WARE-LYNDON HOUSE - Landscape Budget Estimate

From: Amy Kissane <amykissane@bellsouth.net>
Sent: Tuesday, August 12, 2014 4:33 PM
To: Michael Kidd (mkidd@RootDStudio.com); Madie Fischetti (madie@athens-design.com); Derek Doster; Barbara.Andrews@athensclarkecounty.com; Keith.Sanders@athensclarkecounty.com; Mike.Wharton@athensclarkecounty.com; Roger Cauthen (roger.cauthen@athensclarkecounty.com); Ron Evans
Subject: John Waters - Ware-Lyndon SPLOST Project

Ware Lyndon House
Interpretive Garden +
Landscape Improvements
Concept Plan

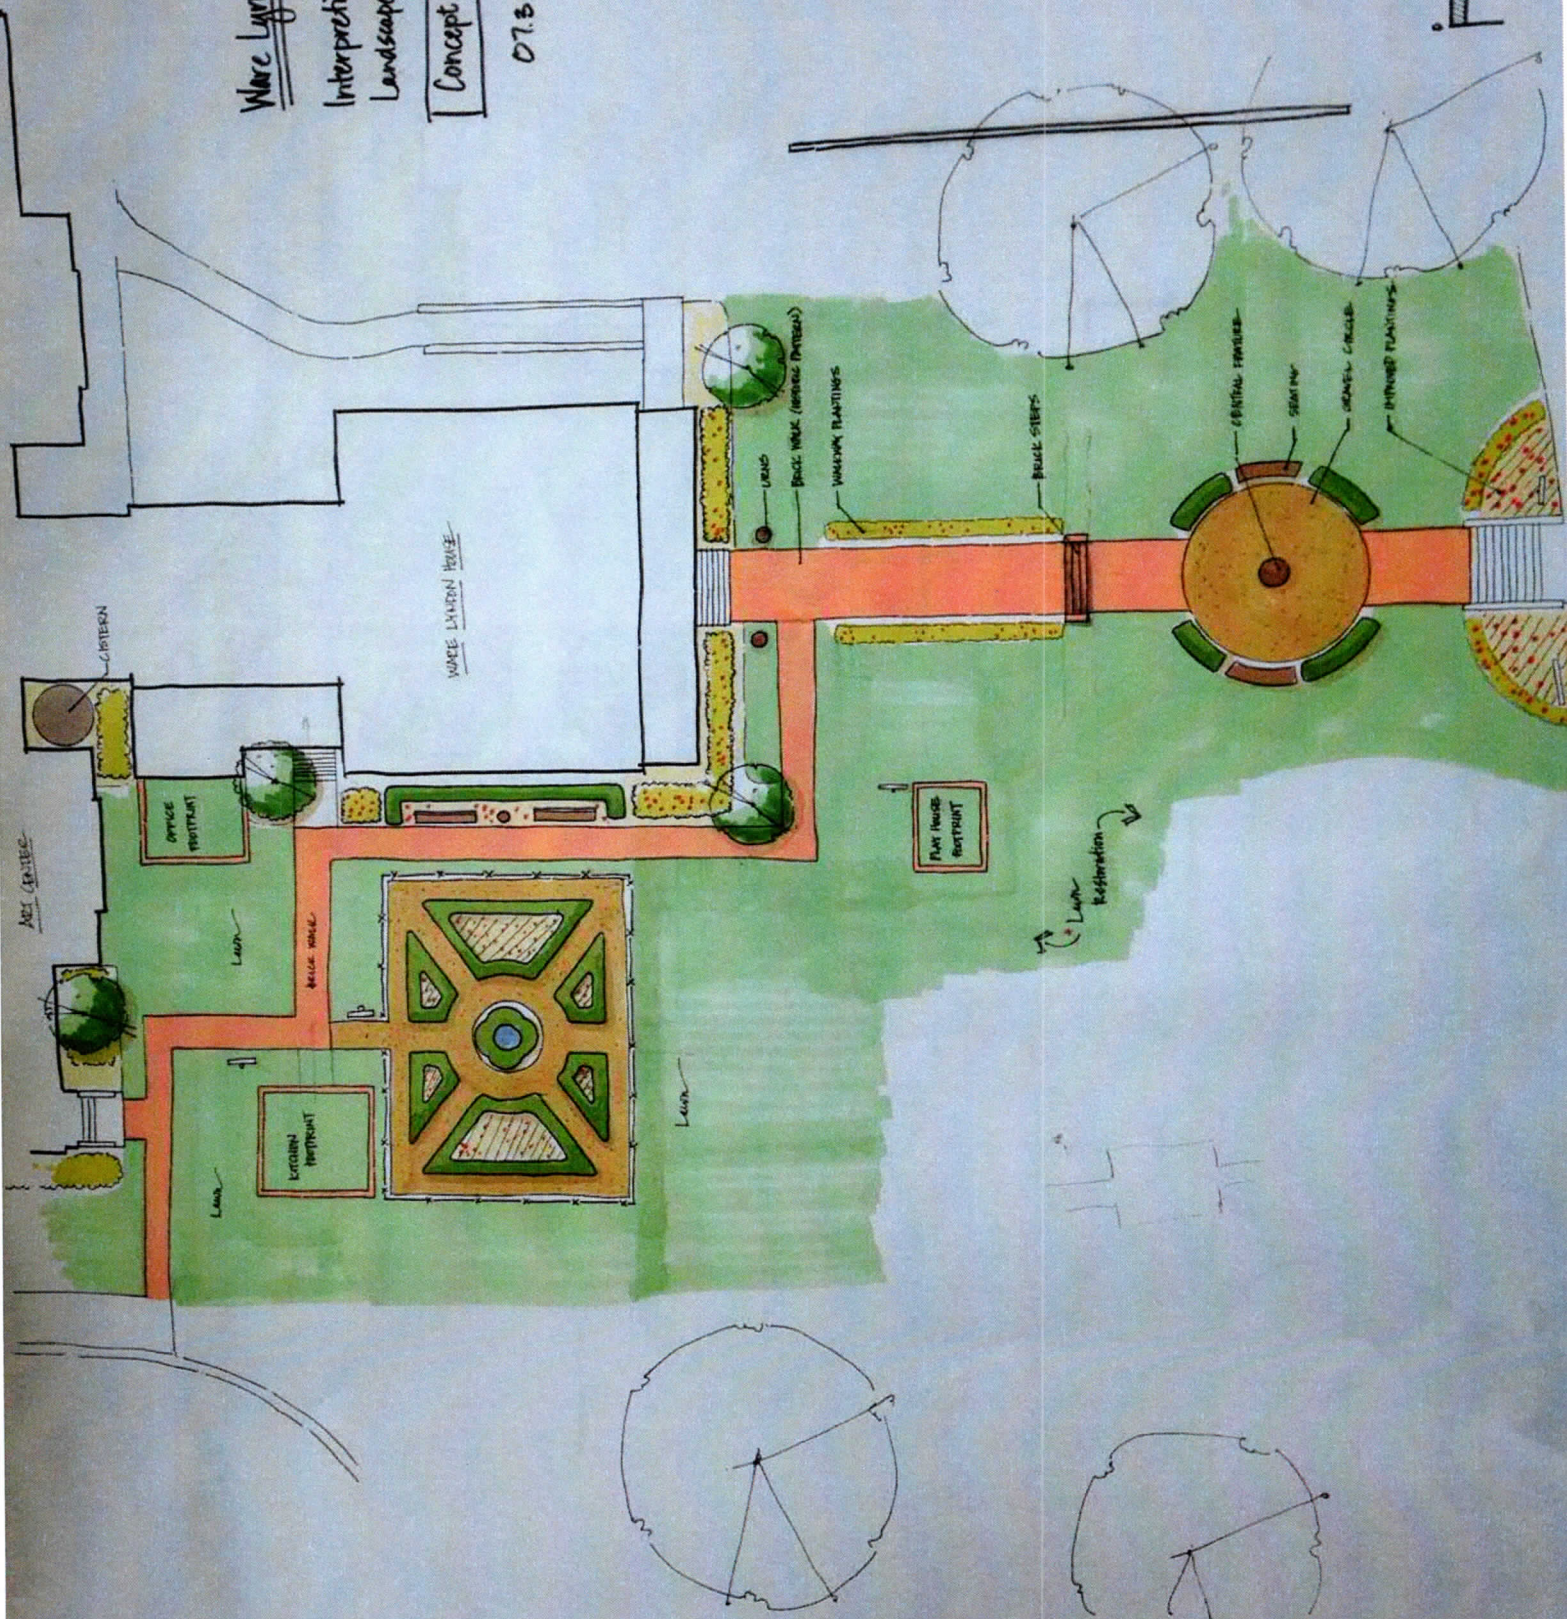
I would like, however, to hear from Madie and Mack about the front treatment, and does this treatment have historic precedence? I know it is not original to the house, except for the axial brick approach, but is the combination of the circle, steps, and axial walkway something that could have been seen historically? I don't want to end up with something that is ahistorical. I know how we got to this point and I know that we are supposed to finalize the concept tomorrow, but I think it would be good—before we approve it—to ask the question, “How will we interpret this design to the public? How will we describe it and explain why it is appropriate for the Ware-Lyndon House?”

- In my opinion, a cultural landscape report should be hand before any plan is finalized.
- Since we are trying to re-create the aura of an historic landscape, non-historic elements and design aspects should be avoided. It seems to me that the goal should be to reinforce the historic character of the site, not distract the visitor with elements which are obviously contemporary additions.
- The entrance walk seems well established from your research and the circle is not historically accurate. I would eliminate that as well as the planting around it as well as the several steps and grade change. The walk, as is, is not a difficult slope, so why go to the expense to add elements and make grade changes that are not supported by site history?

- If you are compelled to do “something.” you might consider a small square terrace, for information purposes at the top of the entrance steps @ Hoyt Street, nothing elaborate, perhaps a bench on one side of the walk and an interpretative panel on the other side. The walk to the house would continue from this point. Since the beds that you have shown have not historic basis related to the historic periods interpreted in the house,(and are not in the character of the 1897 photo you have) I would eliminate them, as they could quickly become a maintenance headache, esp. considering the degree to which ACC budgets are already constrained.

The interpretative panel could show the relationship of house and museum as well as the location (and construction date) of other historic features that do not survive. I do not think it is necessary to create a footprint of these absent features on the ground. This panel should not be a vertical billboard, nor large sized, but one that is low enough to be viewed, perhaps slightly tilted from level, depending on placement. This area would provide site orientation as well as other information, but does not need an auxiliary feature. Depending upon the number and scope of former site features (you mentioned an orchard) perhaps you might want to consider a historic site map(incorporating Sanborne maps) within the Athens History Museum on the first floor of the house that would orient and instruct visitors of the extent and scope of historic site development. If you need a large interpretative panel, it should be down on the Hoyt Street level at the base of the steps, so as not to obscure views toward or from the house.

- If possible, interpretative panels on the site should be flush with the ground level rather than present an object that is a hazard or “intrudes” upon the landscape.

- While not a part of this project, the existing “kitchen garden” is, in my opinion, a parody of what an actual kitchen garden for a household such as this one would have had, in terms of both size and plantings. What is there is a disgrace and should be eliminated. Do you have data on the location of such a garden? In the absence of a shoddy interpretation, I would suggest that such a garden be shown on the site map suggested above and not replicated.

- Question: Is that a handicapped access ramp connecting to the east side of the front porch of the house?
